PARKLETS CAFÉ SEATING/RETAIL AREAS

Car Free California Avenue

December 16, 2025

Outdoor Dining: Seasonal Tents

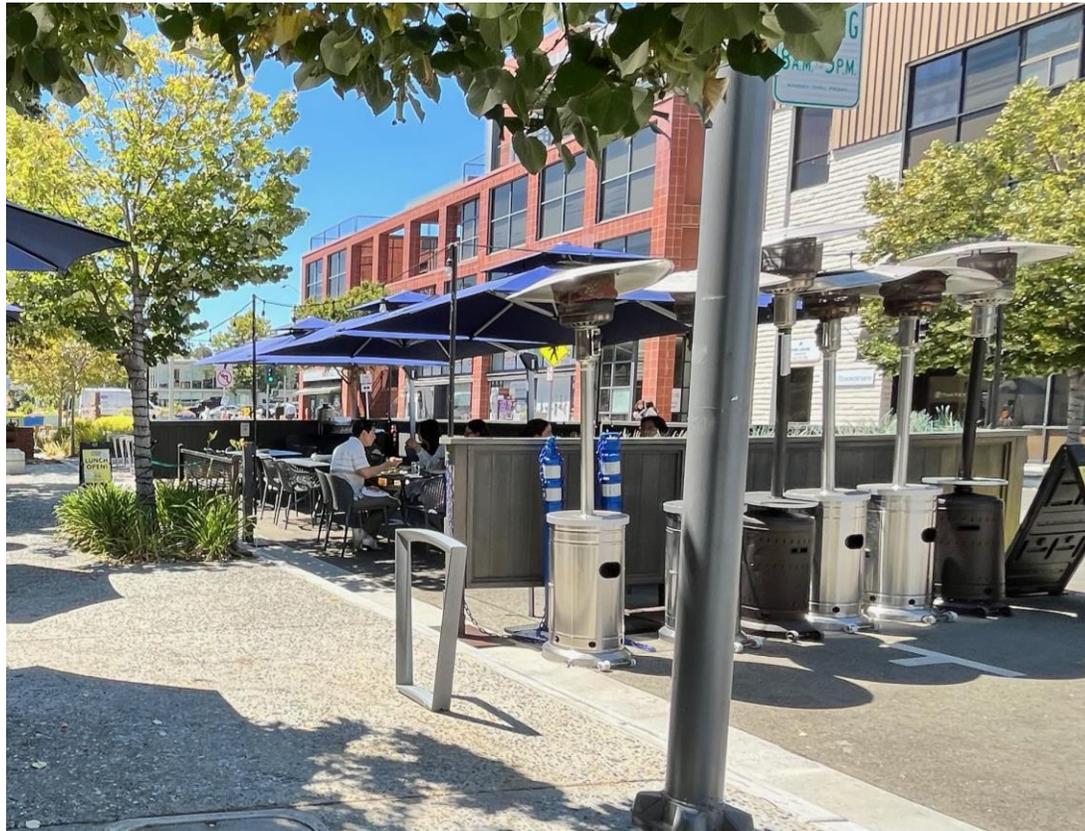
Issue – seasonal tents are temporary, look oversized, frequent violation of propane heater requirements

Proposal – Businesses implement parklets with weather protection features, stop use of tents
